UNITED STATES PATENT AND TRADEMARK OFFICE

APPLICATION NO.	FILING DATE	FIRST NAMED INVENTOR	ATTORNEY DOCKET NO.	CONFIRMATION NO.
10/630,118	07/30/2003	Magnus Bolmsjo	211.312	8332
28785	7590	05/20/2004	EXAMINER	
JOHN R LEY, LCC 5299 DTC BLVD, SUITE 610 GREENWOOD VILLAGE, CO 80111			BOGART, MICHAEL G	
			ART UNIT	PAPER NUMBER
			3761

Office Action Summary

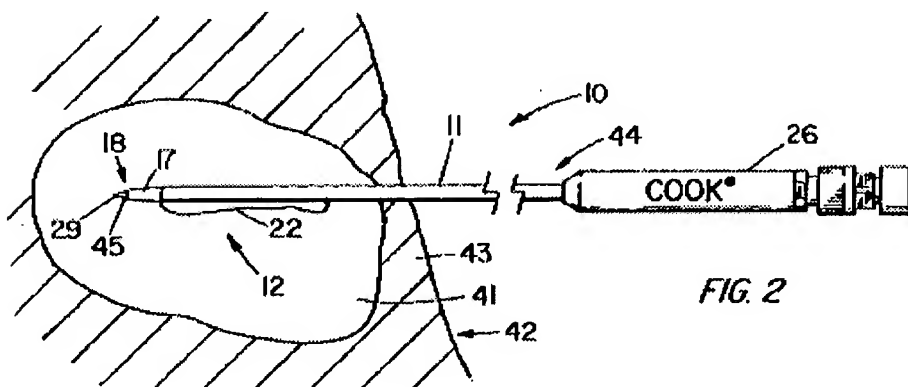
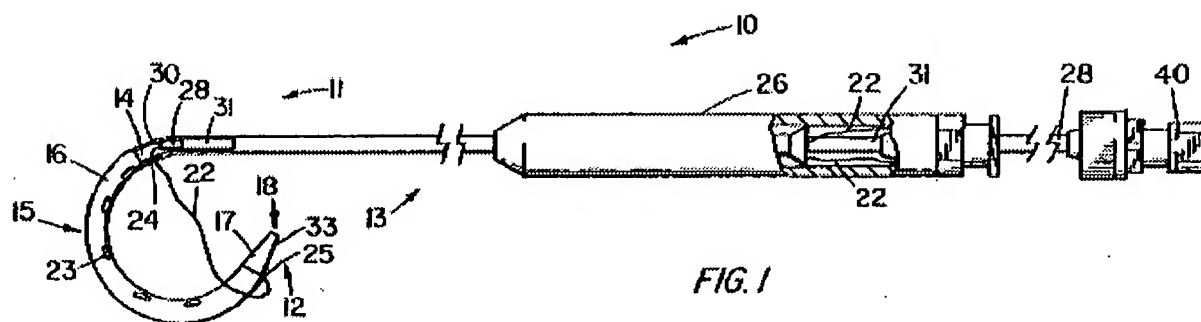
Regarding claim 1, Aldrich *et al.* teach a method for the insertion of a device (10) for the drainage of the bladder through the body's own opening outside of the human body, wherein

a tube-shaped body (11) extends from a first contracted position to an extended second position and is inserted into a longish tube-shaped introducing member (26),

the tube-shaped introducing member (26) is inserted through the body opening, so that an end piece of the tube-shaped body passes into the bladder,

the tube-shaped body (11) is pushed out of the tube-shaped introducing member (26) and into the bladder during the course of which the return of the tube-shaped body (11) to the first

contracted position occurs completely within the bladder and in the course of which the placement of a thread (22) extends outside of the body opening that is attached to the tube-shaped body (11)(col. 3, line 66-col. 4, line 50)(see Figs. 1 and 2, below).

Regarding claim 13, Aldrich *et al.* teach an introducing (26) apparatus for the insertion of an elongated urine drainage apparatus (10) into a bladder, the drainage apparatus (10) comprising a tube shaped body (11) that has a first contracted position (Fig. 1) and a second extended position (Fig. 2) and a thread (22) attached to one end (18), the introducing apparatus (26) comprising:

a flexible guide (31) that has a length sufficient to extend from an exterior opening of a body through to the bladder, and

the flexible guide (31) has a transverse dimension to fit within the tube shaped body (11) when the body (11) is in the extended position, and

the flexible guide (31) has sufficient rigidity to temporarily hold the tube-shaped body (11) in the extended position when the flexible guide (31) is inserted in the body (11)(col. 4, lines 29-50).
